In response to following issue raised:
1. Overshadowing.
The proposed building envelope results in additional overshadowing of nearby Special Areas (as identified in the North Sydney LEP 2001). Further envelope massing options should be prepared which demonstrate maintenance of solar access to the Miller Street Special Area and the Don Bank Museum Special Area between 10am and 2pm throughout the year, with particular reference to the Equinoxes. The options should indicate any impact on floor space and floor plate areas arising from compliance with Clause 28D (2) (c) of the NSLEP 2001.

The following envelope studies for the site at 177-199 Pacific Highway can be defined through the following keypoints:

Response to DOP letter
(30th August 2010)

Study 2.
Functional building envelope for no overshadowing to Don Bank Museum Special Area at equinoxes
Autumn Equinox, 21st March @10am

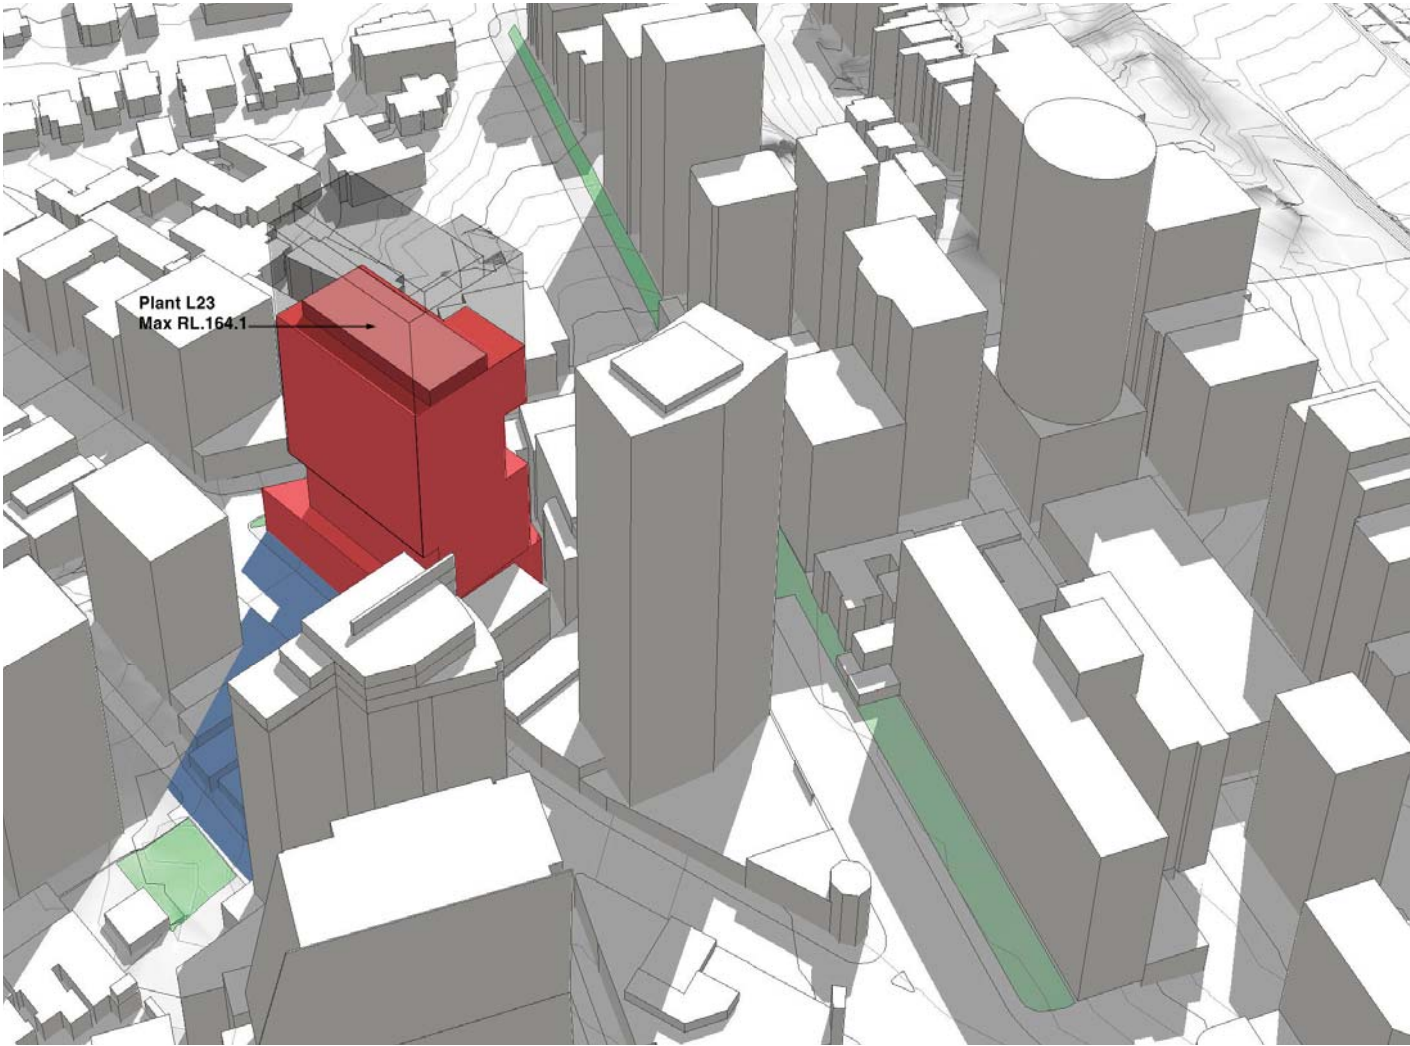
In response to following issue raised:
1. Overshadowing.
The proposed building envelope results in additional overshadowing of nearby Special Areas (as identified in the North Sydney LEP 2001). Further envelope massing options should be prepared which demonstrate maintenance of solar access to the Miller Street Special Area and the Don Bank Museum Special Area between 10am and 2pm throughout the year, with particular reference to the Equinoxes. The options should indicate any impact on floor space and floor plate areas arising from compliance with Clause 28D (2) (c) of the NSLEP 2001.

>Max Ht: RL 164.1 (Top of plant Level 23)
>Achievable GFA: 31,490sqm (Loss of 13,280sqm)

Resultant envelope is functional but not economic

Study 3.
Achievable building envelope for no overshadowing to Miller Street Special Area at Equinoxes with stepped form to maximise GFA. Spring Equinox, 23rd September @2pm

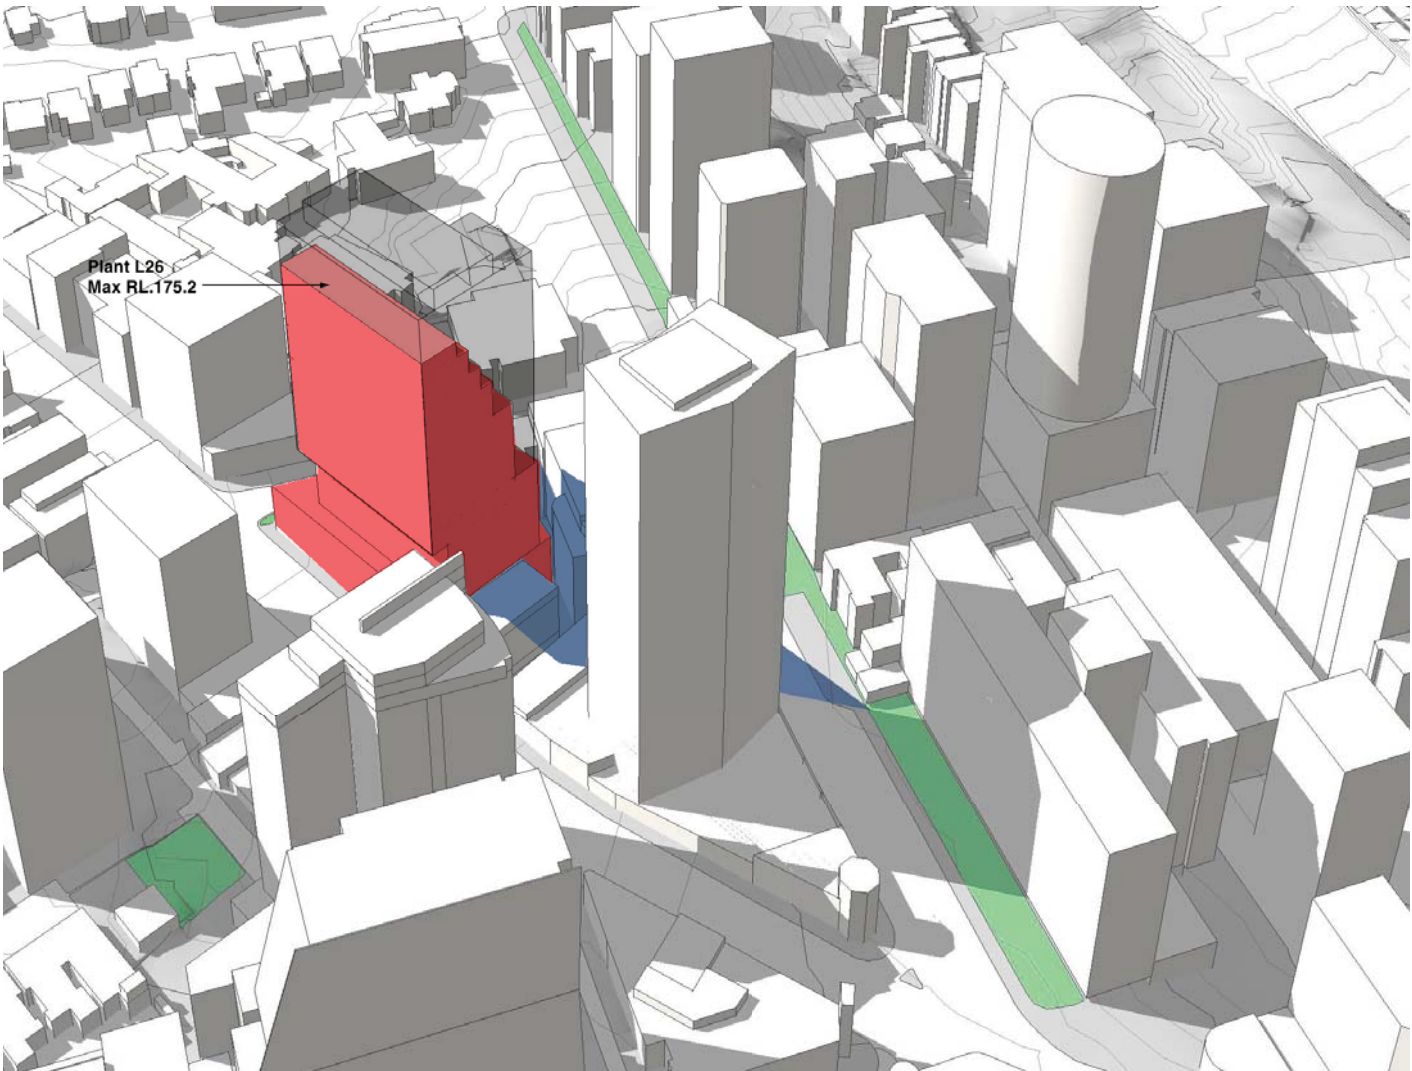
In response to following issue raised:
1. Overshadowing.
The proposed building envelope results in additional overshadowing of nearby Special Areas (as identified in the North Sydney LEP 2001). Further envelope massing options should be prepared which demonstrate maintenance of solar access to the Miller Street Special Area and the Don Bank Museum Special Area between 10am and 2pm throughout the year, with particular reference to the Equinoxes. The options should indicate any impact on floor space and floor plate areas arising from compliance with Clause 28D (2) (c) of the NSLEP 2001.

>Max Ht: RL 175.2 (Top of plant Level 26)
>Achievable GFA: 35,725sqm (Loss of 9,045sqm)

Resultant envelope is achievable but largely disfunctional

Study 4.
Functional building envelope for no overshadowing to Miller Street Special Area at equinoxes
Spring Equinox, 23rd September @2pm

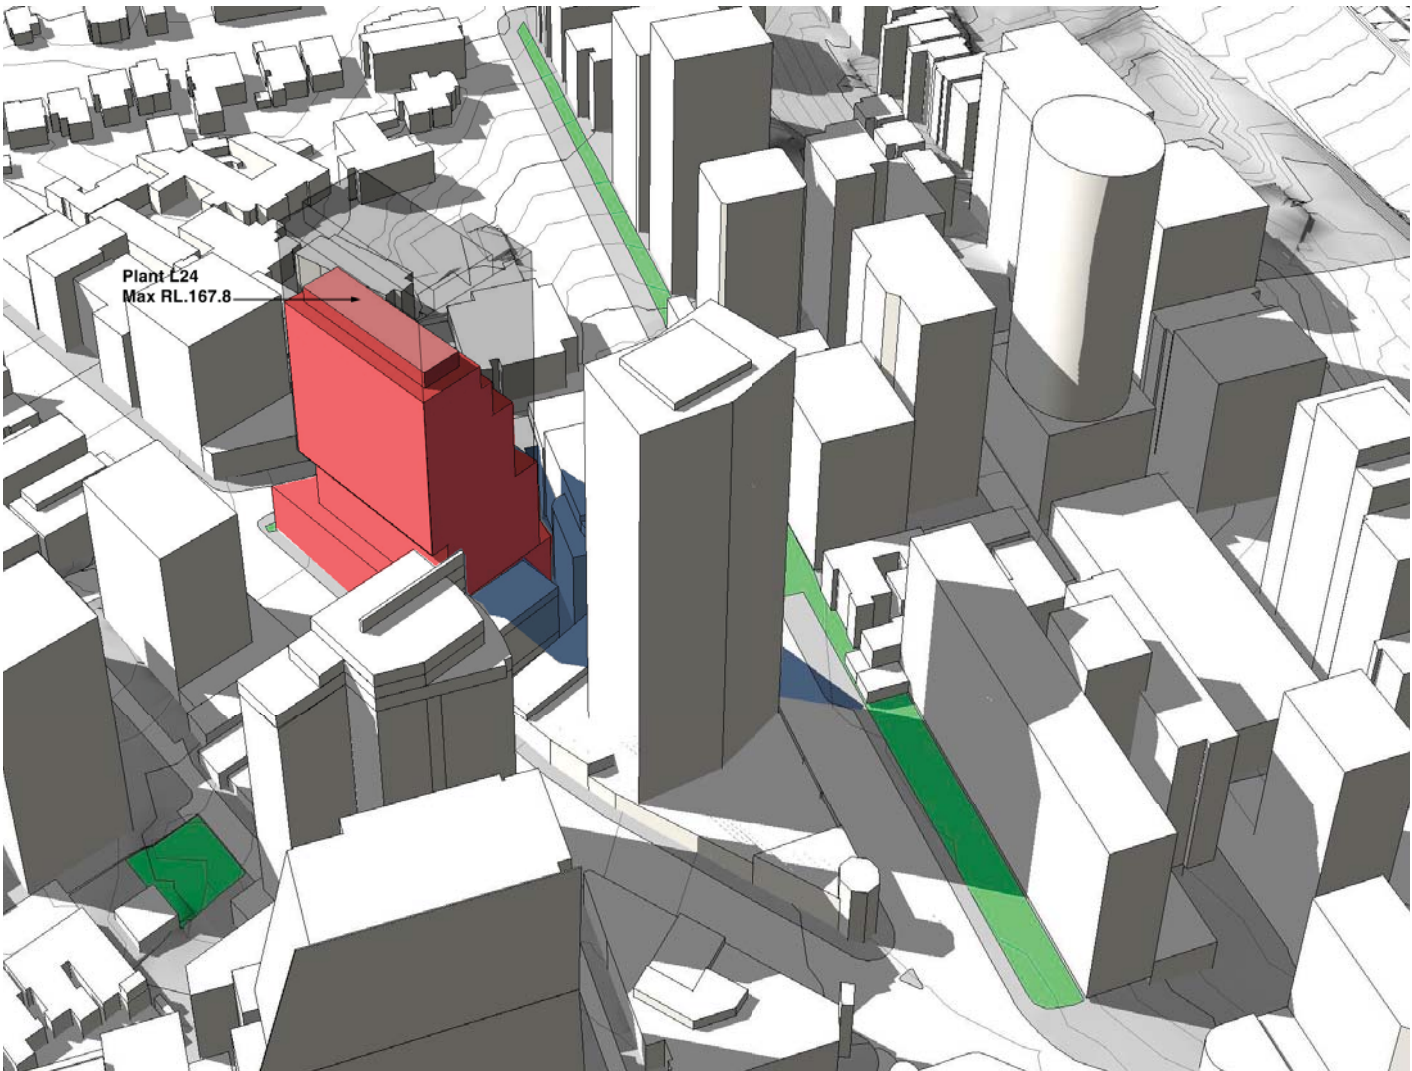
In response to following issue raised:
1. Overshadowing.
The proposed building envelope results in additional overshadowing of nearby Special Areas (as identified in the North Sydney LEP 2001). Further envelope massing options should be prepared which demonstrate maintenance of solar access to the Miller Street Special Area and the Don Bank Museum Special Area between 10am and 2pm throughout the year, with particular reference to the Equinoxes. The options should indicate any impact on floor space and floor plate areas arising from compliance with Clause 28D (2) (c) of the NSLEP 2001.

>Max Ht: RL 167.8 (Top of plant Level 24)
>Achievable GFA: 33,770sqm (Loss of 11,000sqm)

Resultant envelope is functional but not economic

Study 5.
Achievable building envelope for no overshadowing to Miller Street Special Area and Don Bank Museum Special Area
Autumn Equinox, 21st March @10am

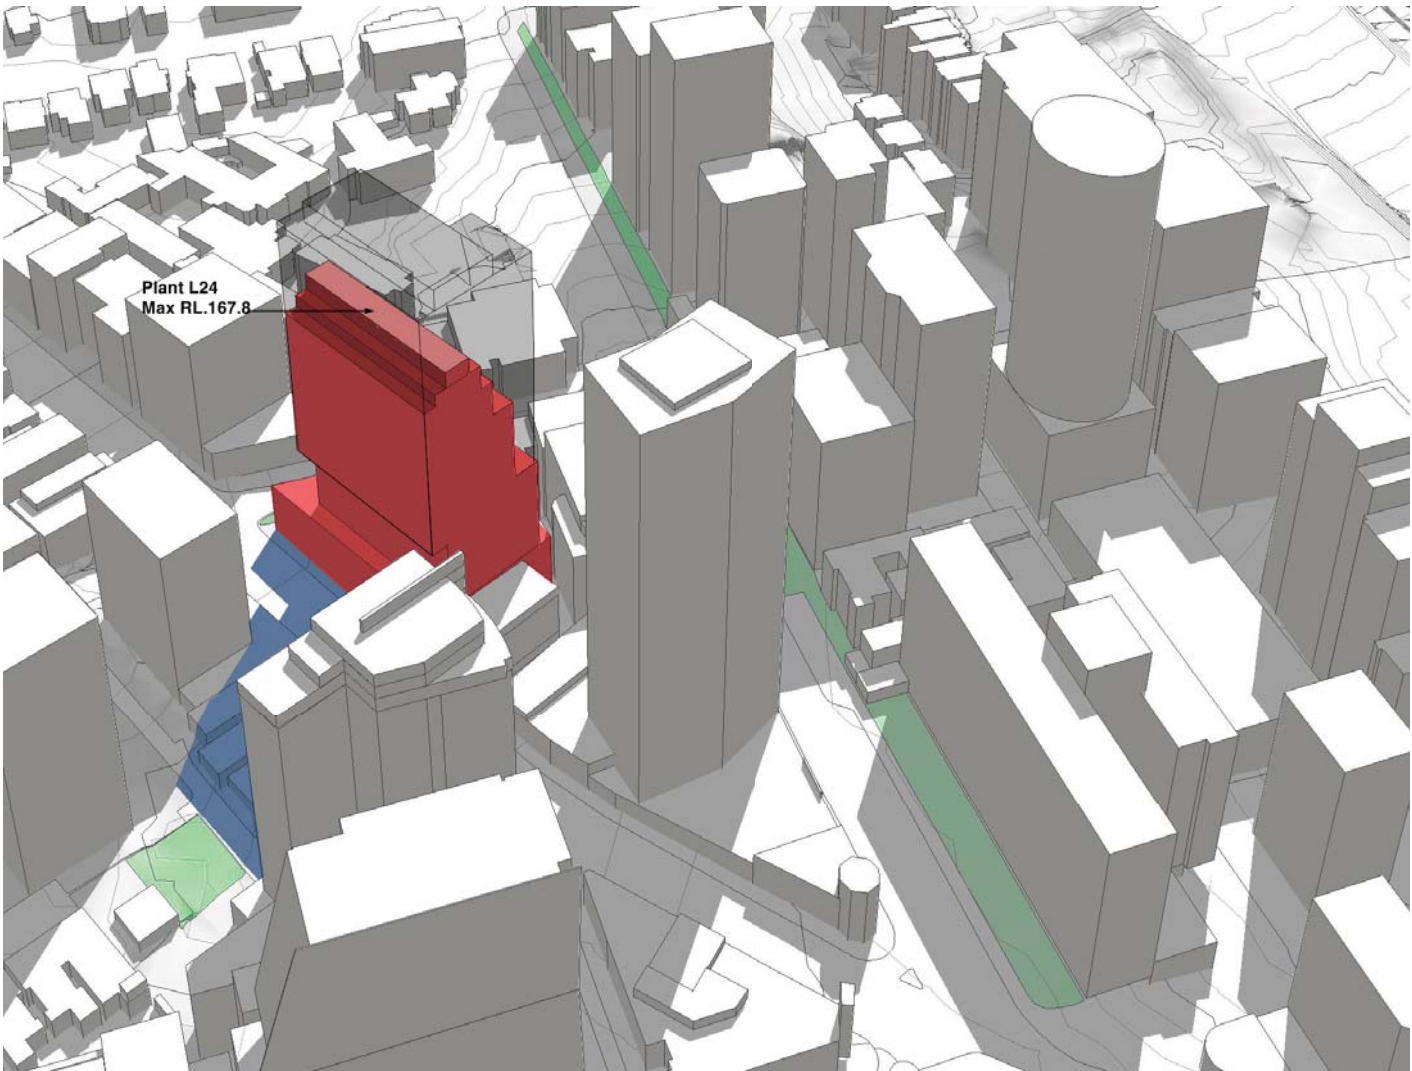
In response to following issue raised:
1. *Overshadowing.*
The proposed building envelope results in additional overshadowing of nearby Special Areas (as identified in the North Sydney LEP 2001). Further envelope massing options should be prepared which demonstrate maintenance of solar access to the Miller Street Special Area and the Don Bank Museum Special Area between 10am and 2pm throughout the year, with particular reference to the Equinoxes. The options should indicate any impact on floor space and floor plate areas arising from compliance with Clause 28D (2) (c) of the NSLEP 2001.

>Max Ht: RL 167.8 (Top of plant Level 24)
>Achievable GFA: 32,360sqm (Loss of 12,410sqm)

Resultant envelope is achievable but largely disfunctional

Study 5A.
Achievable building envelope for no overshadowing to Miller Street Special Area and Don Bank Museum Special Area
Critical Day, 28th August @2pm

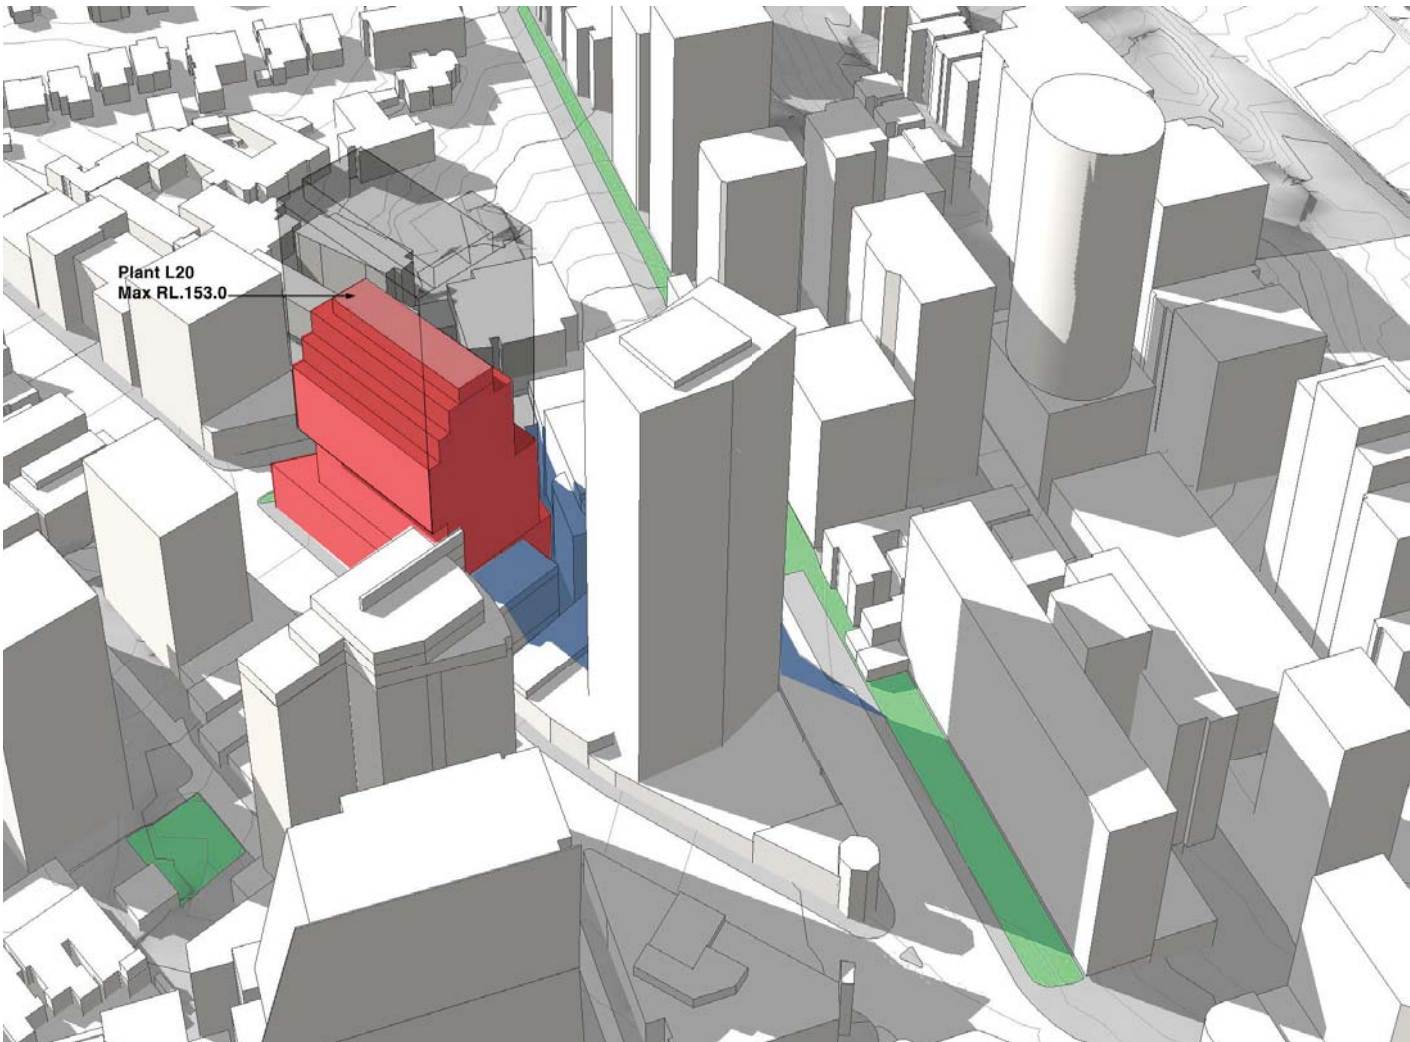
In response to following issue raised:
1. Overshadowing.
The proposed building envelope results in additional overshadowing of nearby Special Areas (as identified in the North Sydney LEP 2001). Further envelope massing options should be prepared which demonstrate maintenance of solar access to the Miller Street Special Area and the Don Bank Museum Special Area between 10am and 2pm throughout the year, with particular reference to the Equinoxes. The options should indicate any impact on floor space and floor plate areas arising from compliance with Clause 28D (2) (c) of the NSLEP 2001.

>Max Ht: RL 153.0 (Top of plant Level 20)
>Achievable GFA: 25,485sqm (Loss of 19,285sqm)

Resultant envelope is achievable but largely disfunctional

Study 6.
Functional building envelope for no overshadowing to Miller Street Special Area and Don Bank Museum Special Area
Autumn Equinox, 21st March @10am

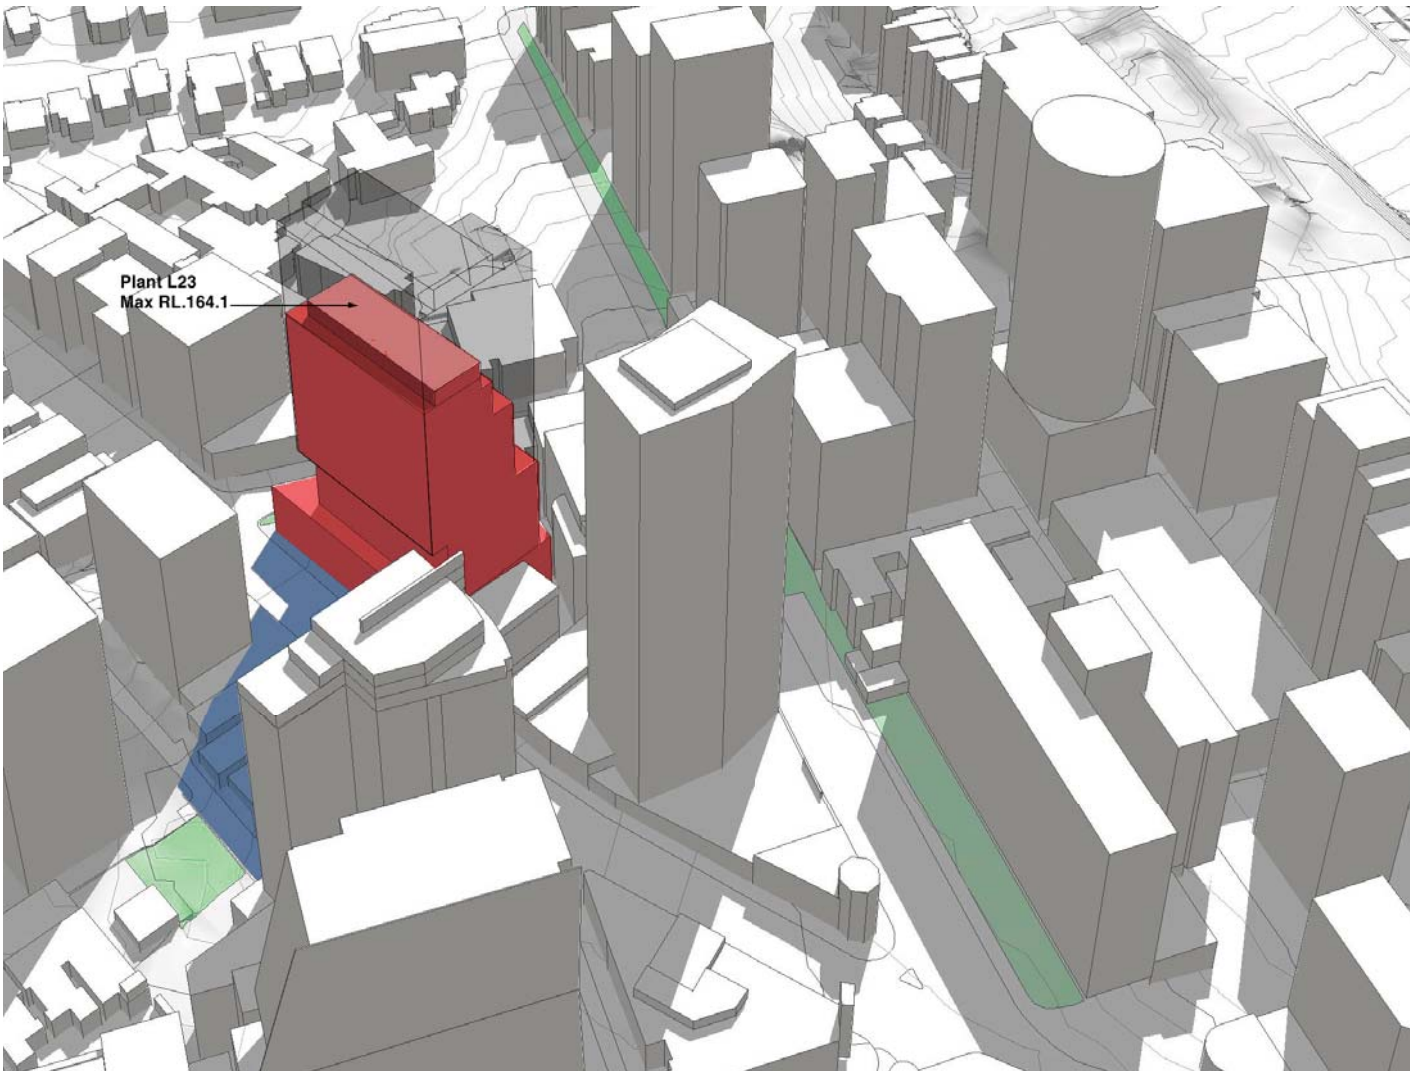
In response to following issue raised:
1. *Overshadowing.*
The proposed building envelope results in additional overshadowing of nearby Special Areas (as identified in the North Sydney LEP 2001). Further envelope massing options should be prepared which demonstrate maintenance of solar access to the Miller Street Special Area and the Don Bank Museum Special Area between 10am and 2pm throughout the year, with particular reference to the Equinoxes. The options should indicate any impact on floor space and floor plate areas arising from compliance with Clause 28D (2) (c) of the NSLEP 2001.

>Max Ht: RL 164.1 (Top of plant Level 23)
>Achievable GFA: 31,490sqm (Loss of 13,280sqm)

Resultant envelope is functional but not economic
